CITY OF ALBUQUERQUE

Re: Sandia Acrobatic Gymnastics Academy
3400 Candelaria Rd. NE
Traffic Circulation Layout
Architect's Stamp 09-29-17 (H16D152)

DRAINAGE AND TRANSPORTATION INFORMATION SHEET (REV. 09/2015)

TRAFFIC CIRCULATION
PLAN

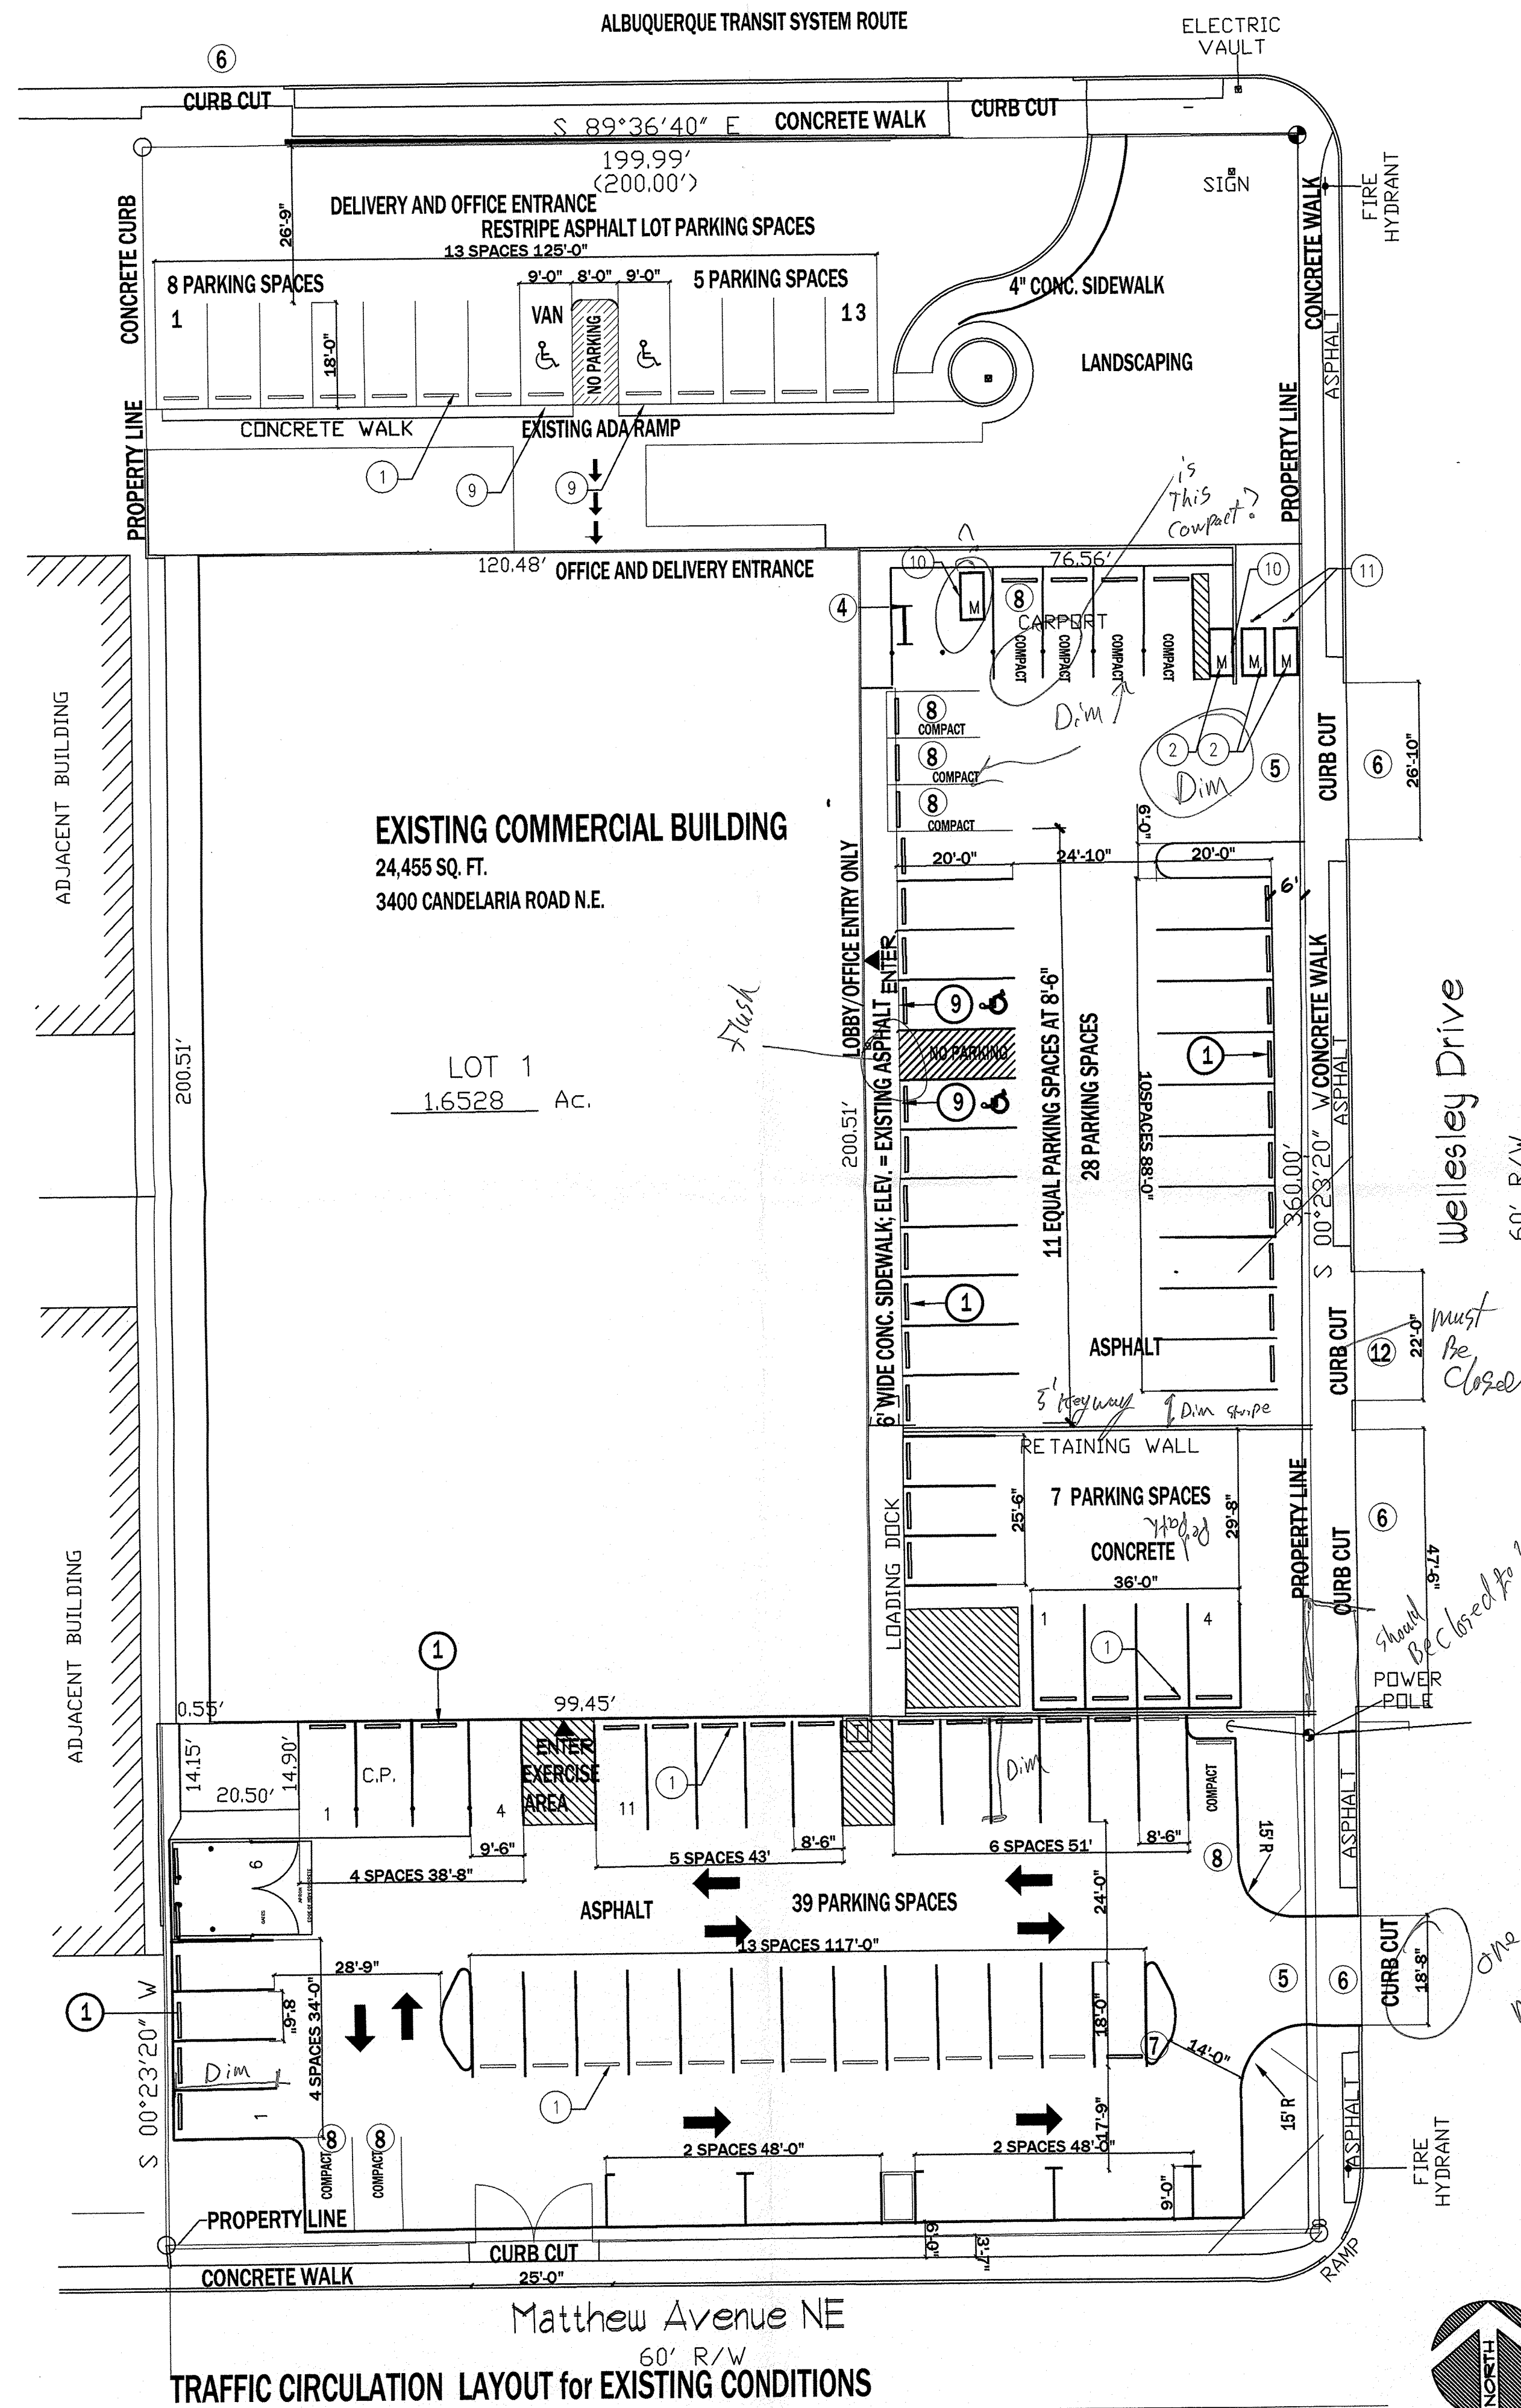
1. Add a scale to the plan view.
2. Please list the width and length for all existing and proposed parking spaces. Some dimensions are not shown. Provide the lengths of the parking stalls where no dimension is shown.

3. The compact spaces at the north of the site look like they are standard size.
4. ADA curb ramps must be updated to current standards and have truncated domes installed. The ADA ramp on Candelaria Rd. and Wellesley Dr must be updated to current ADA standards.

5. Motorcycle parking spaces should be dimensioned. The motorcycle space closed in by parking spaces will not be allowed. Provide the # of required motorcycle spaces.

6. Please dimension all new and existing curb cuts on site.
7. List radii for all curves shown; for passenger vehicles, the minimum end island radius for passenger vehicles is 15 ft. Radius for delivery trucks, fire trucks, etc. is 25 ft. or larger. Please indicate the radii on the end islands.

8. A 5 ft. keyway is required for dead-end parking aisles.
9. One-way vehicular paths require pavement directional signage and a posted **"Do Not Enter"** sign at the point of egress. Please show detail and location of posted signs. The 18 foot curb cut is not big enough for two way travel must be a minimum of 24 feet.

10. Please specify the City Standard Drawing Number when applicable.
11. Unused curb cuts must be replaced with sidewalk and curb & gutter. A build note must be provided referring to the appropriate City Standard drawing. The

drive entrance next to the loading dock must be closed with curb, gutter and sidewalk.
